MEMORANDUM

Subject: Campus Planning Committee Meeting, December 10, 2015

**1. Oregon Bach Festival (OBF) Music Building Addition Project - Check-in**

Oregon Bach Festival Building Addition to the School of Music and Dance  
Campus Planning Committee - Meeting 3 December 10, 2015

AERIAL LOOKING NORTH - EAST

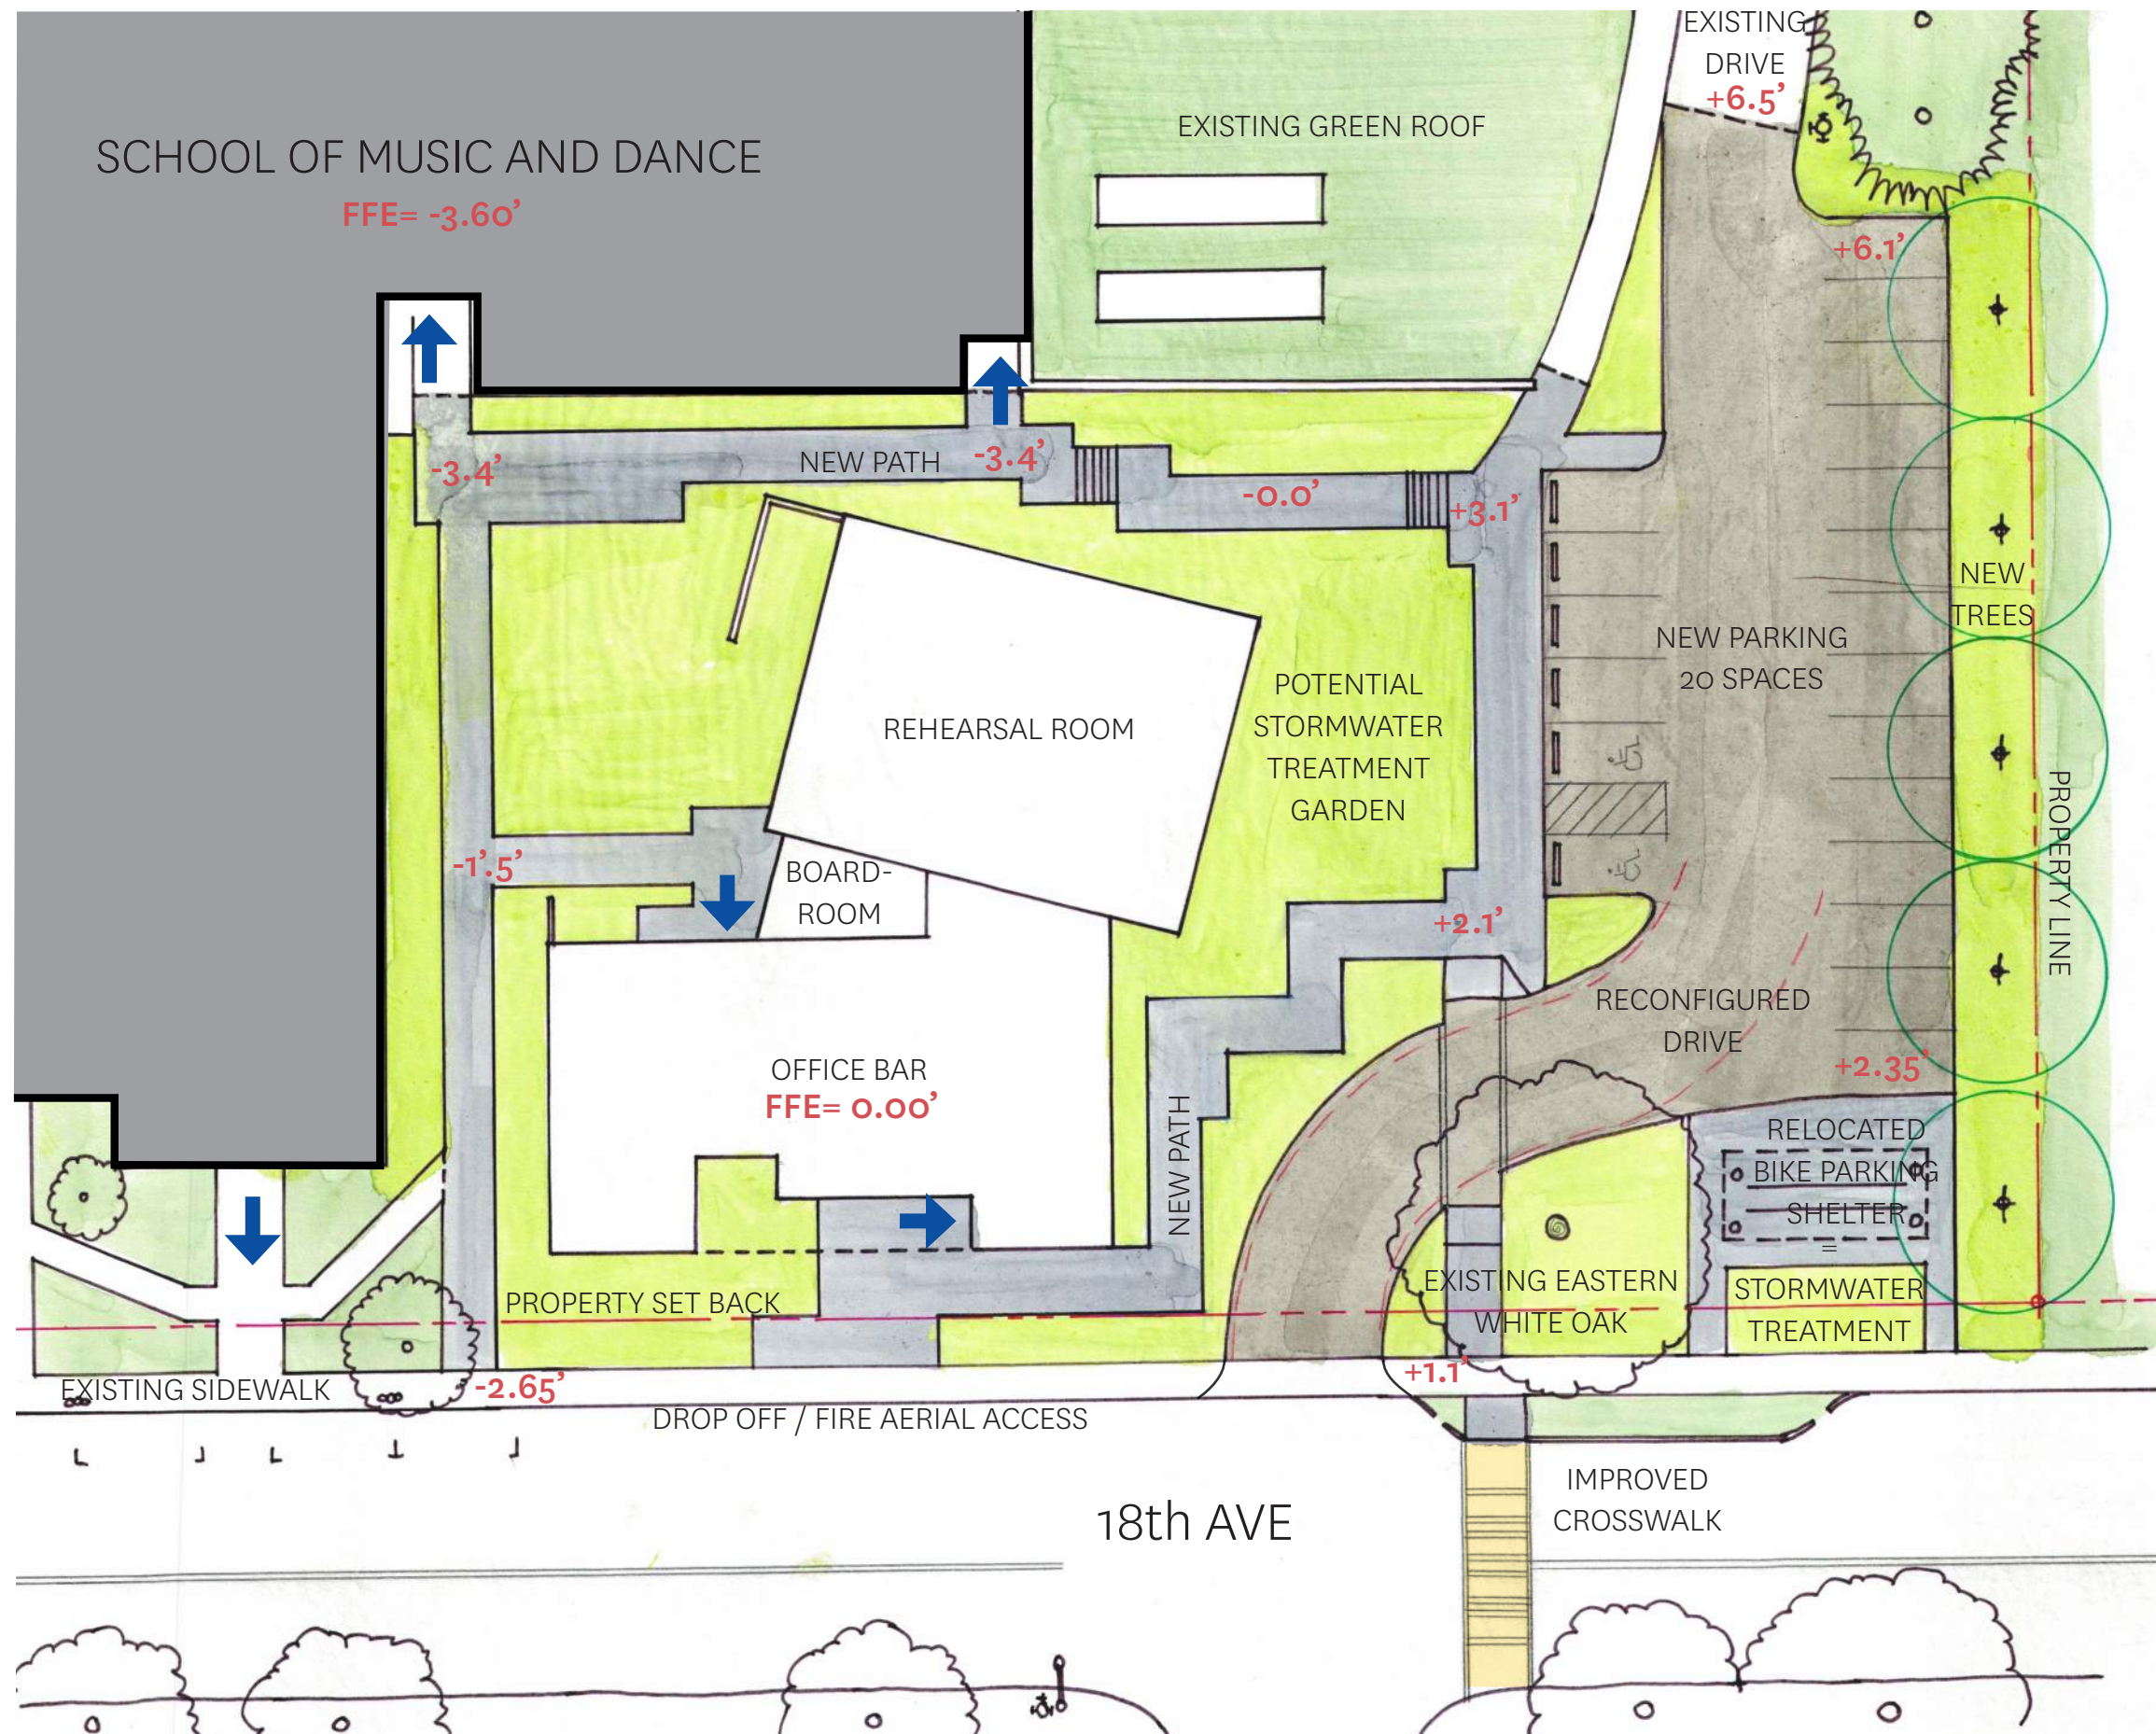
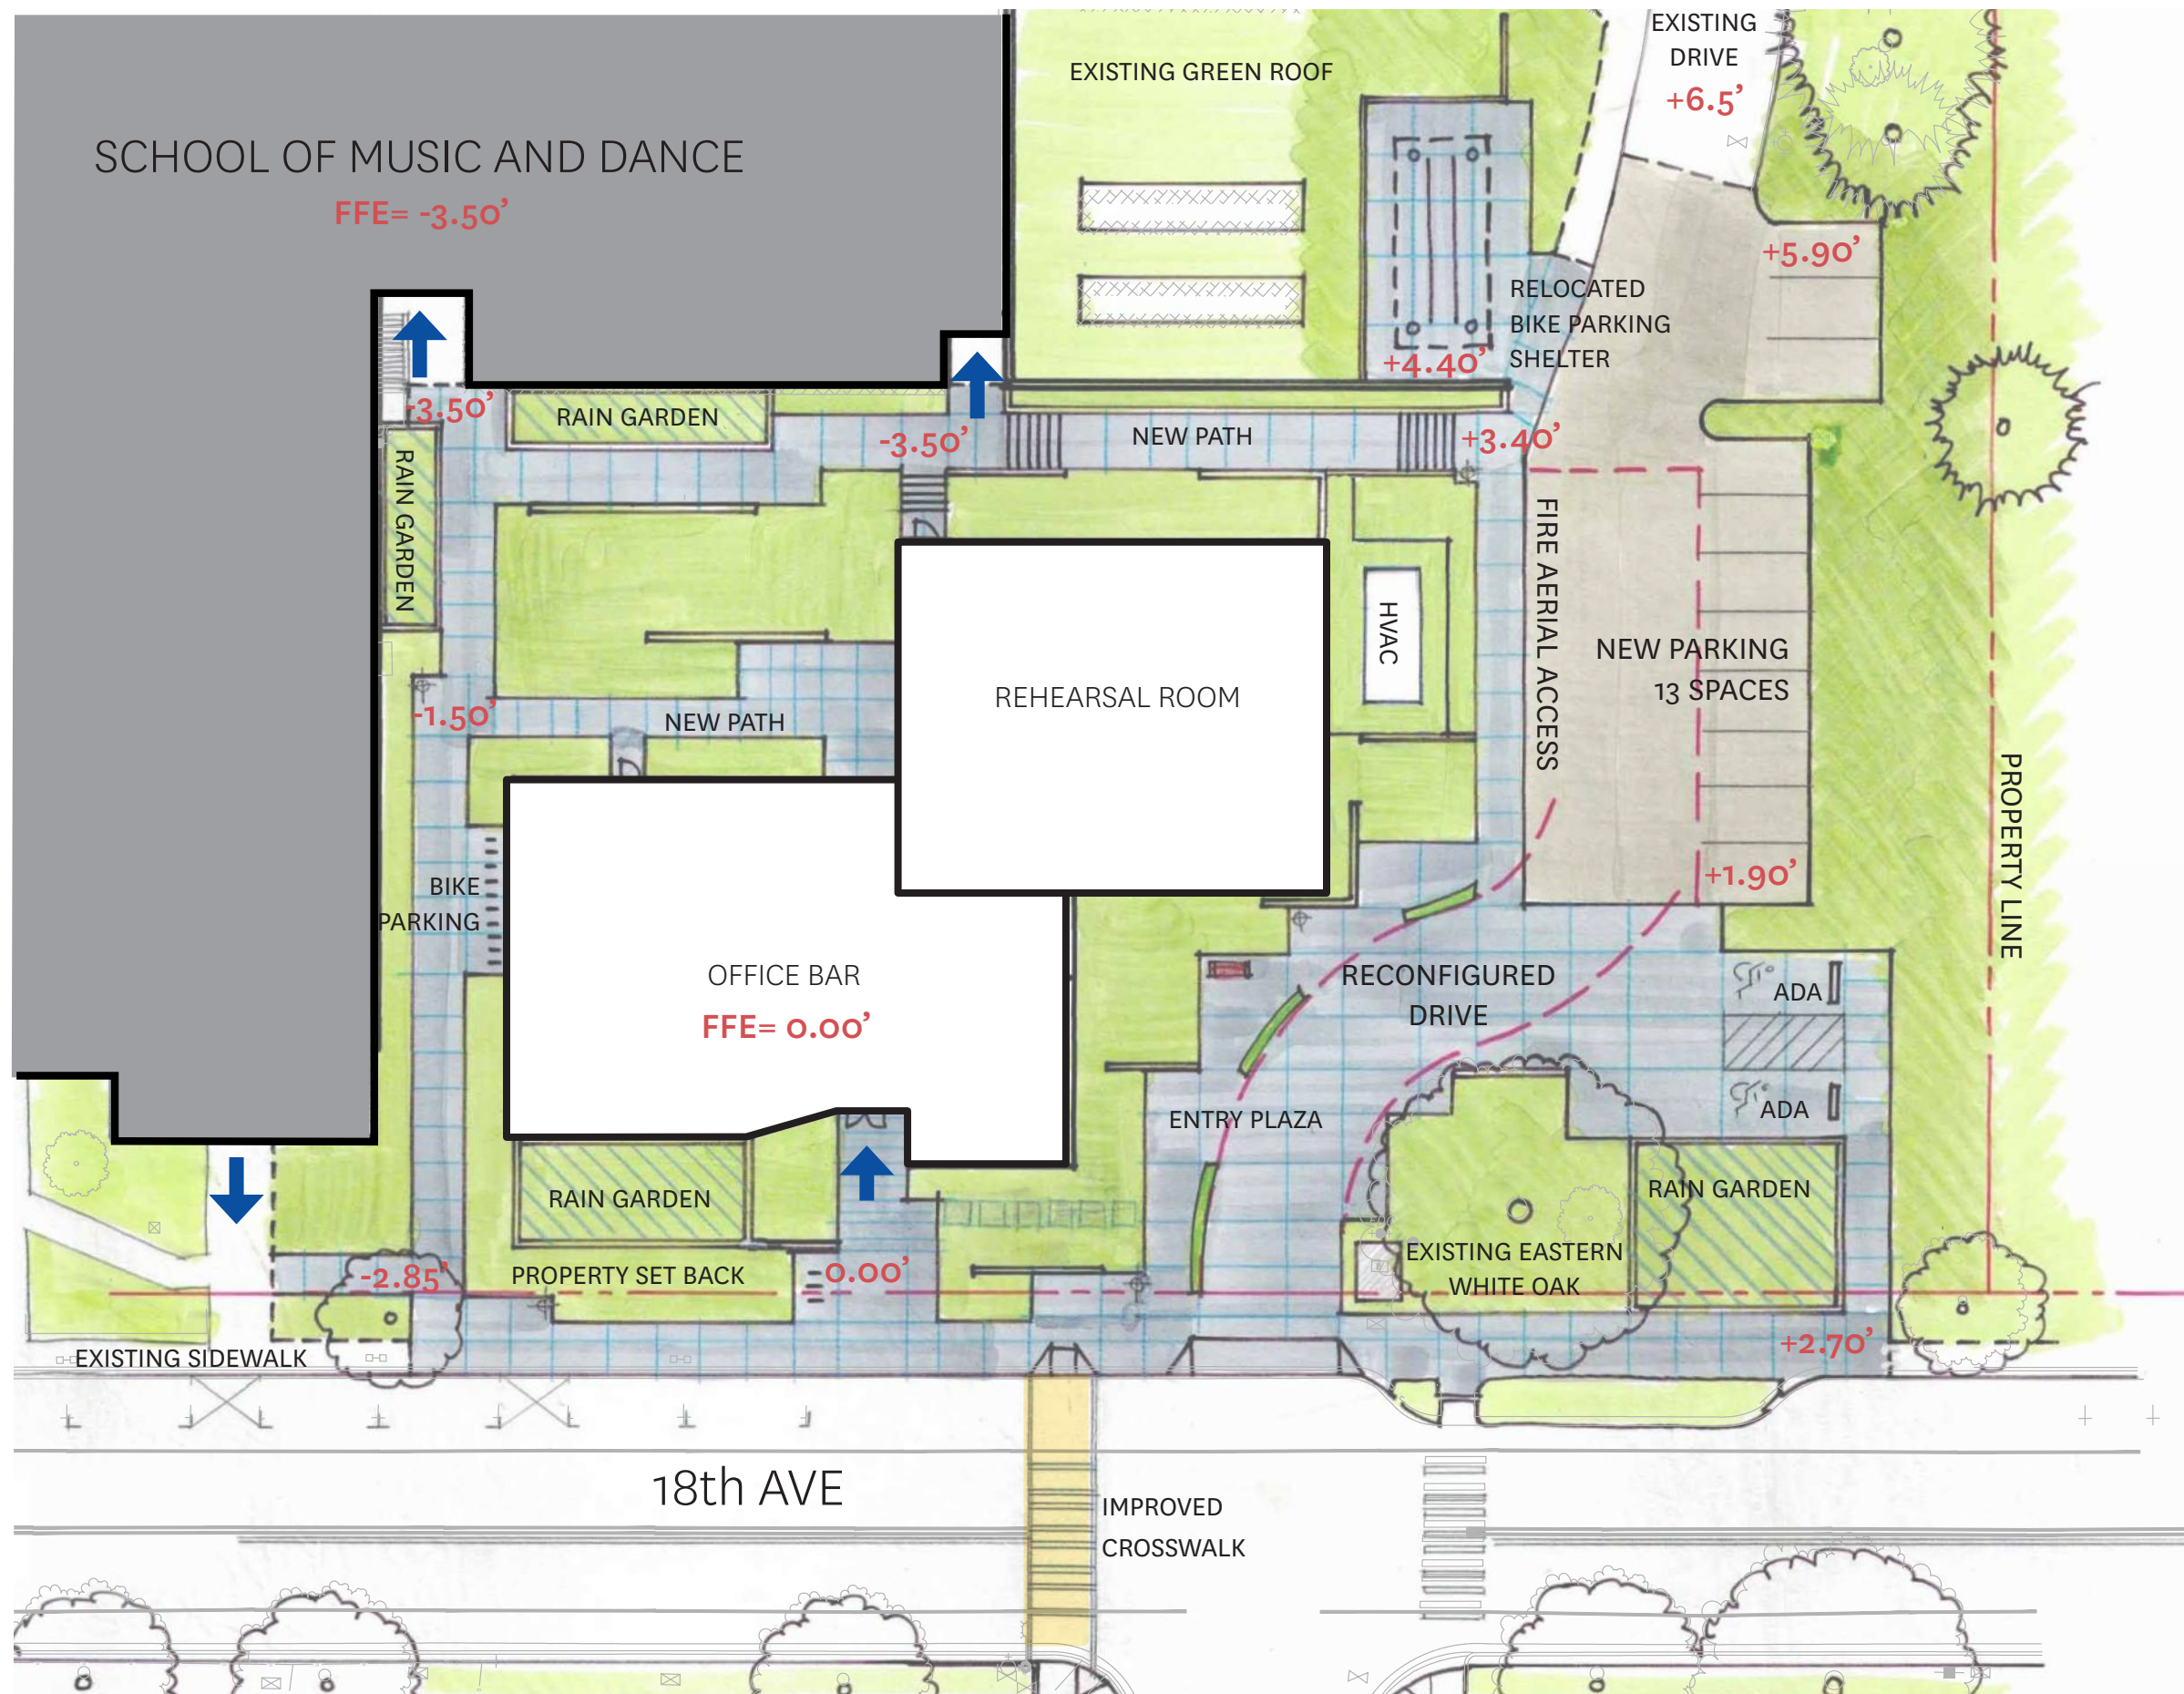
- Research options to move covered bike parking closer to building entrances in a more convenient location for regular cyclists. Keep in mind the UO Transportation Policy, which prioritizes bike parking over vehicular parking. One possible location to consider is north of the proposed addition near (or on) the existing green roof. Proximity to entrances is more important than being in direct public view.

- Regarding Policy 10: Sustainable Development, consider solar panels on the proposed addition, which seems well positioned for solar access.
- Reassess the proposed development's relationship to the 18th Avenue streetscape (e.g., the existing Music Building façade, designated open-space, drive, and Pioneer Cemetery). The proposed addition should be integrated into the existing building complex versus the dominant feature.

- Carefully assess proposed changes and improvements to the drive. Consider its relationship to the existing designated open-space and circulation network. If pedestrian travel is encouraged along the drive, improvements along the entire route to the Southwest Green should be considered, not just a portion.

- Carefully consider treatment of the Pioneer Cemetery edge. While not UO-owned, it is an important open-space element and should be treated as such.
- Reconsider the merits of the proposed "tipped" rehearsal building. Buildings that are not aligned with the campus's orthogonal structure are generally not acceptable unless there is a very compelling reason.

- Reassess ways to enlarge the new courtyard by reorienting and shifting the proposed addition further east. Ensure that the courtyard is a welcoming and functional positive outdoor space.

- Ensure access needs for the 100-140 capacity rehearsal hall are addressed.
- Keep in mind the need to transport instruments from the parking area and Music Building.
- Reassess the possibility of shifting the drive entry further east to resolve limited development space and simplify pedestrian/bike circulation (recognizing the need to work with the City).
- Consider ways to decrease and/or shift the number of parking spaces adjacent to the proposed addition to resolve pedestrian circulation and enhance landscaping connections to Pioneer Cemetery.
- Account for service access.
- Carefully assess ways to create more direct and clearer routes for pedestrians and bicyclists traveling from 18th Avenue along the north/south drive as well as to the existing Music Building and proposed addition entrances.

The project team has revised the site plan and building layout, in response to the feedback received at the first check-in meeting. The project is coming to the committee on December 10 as a second check-in meeting. The project team has revised the site plan and building massing configuration in response to the feedback received at the first check-in meeting on November 16, 2015, described below.
